FAIRFAX COUNTY PLANNING COMMISSION

PUBLIC HEARING FOR PLANNING DETERMINATION

Application Number: **2232-M18-28**

Proposed Use: Replacement Facility for the Edsall Road Fire Station

EDSALL ROAD FIRE STATION #26
RENOVATION & ADDITION
5316 CAROLINA PL, SPRINGFIELD, VA
LANDSCAPE PLAN & DETAILS

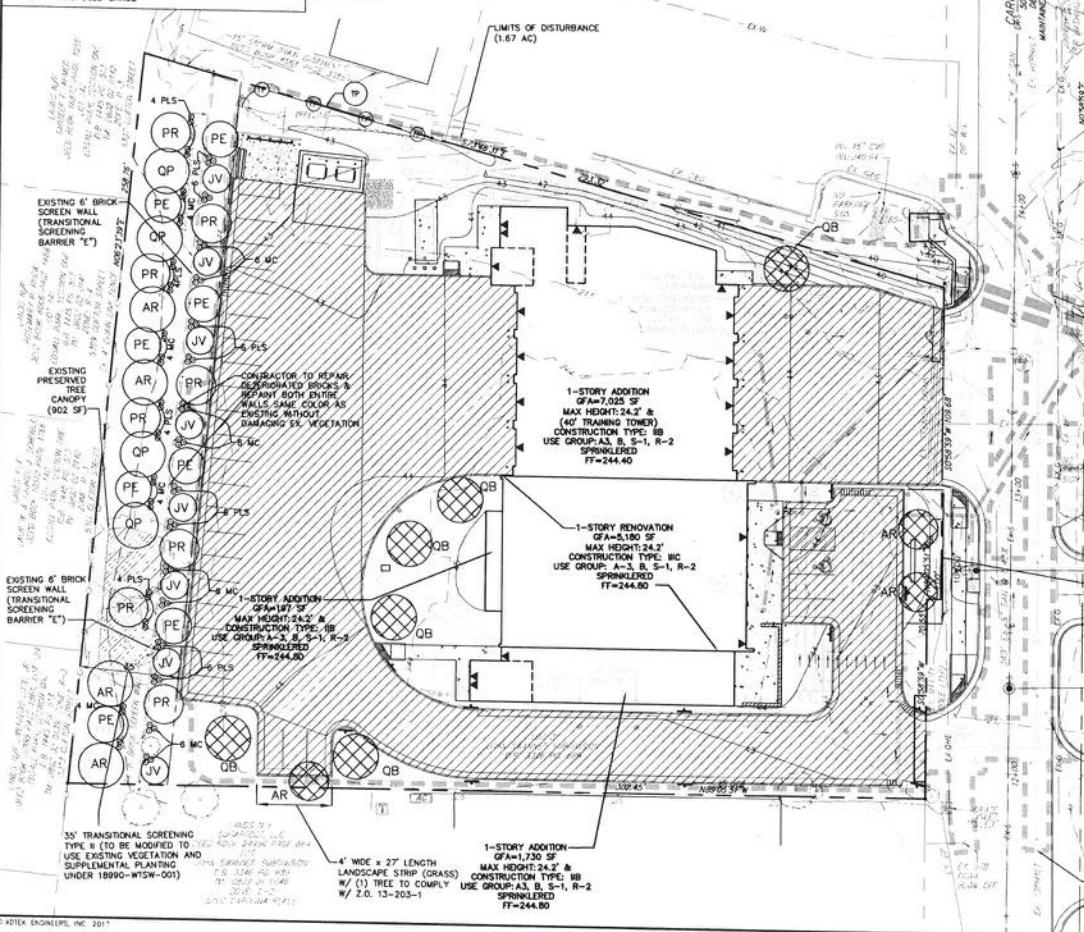
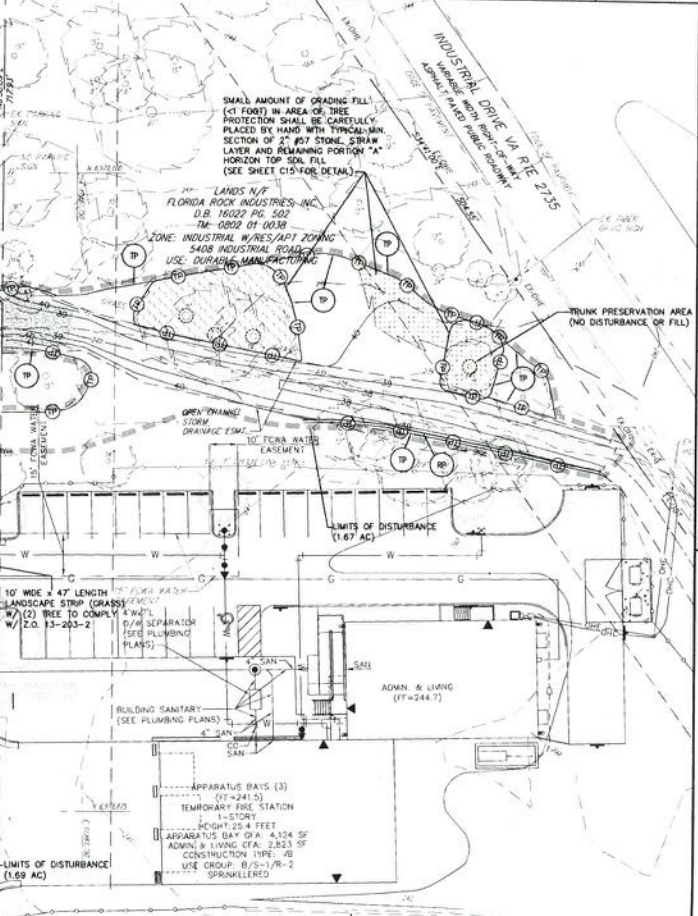
- In response, the applicant stated a combination of deciduous trees, evergreens, and shrubs will be planted in the 10-foot area that previously had no vegetation.

- The landscape planting schedule shall be updated accordingly.
 - In response, the applicant updated the planting schedule.
- A transitional screening matrix shall be provided to clarify that it meets the intent of the Zoning Ordinance for a 35-foot-wide screening yard.

Response: A combination of large deciduous, large and medium evergreens and shrubs has now been planted within the 10 foot area that previously had no vegetation, see Sheet C14.

Response: The landscape planting schedule has been updated on Sheet C14.

Response: Transitional screening matrix has now been included on Sheet C14.

Response: Table 12.10 has been updated on Sheet C32 for the proposed plantings depicted on Sheet C14.
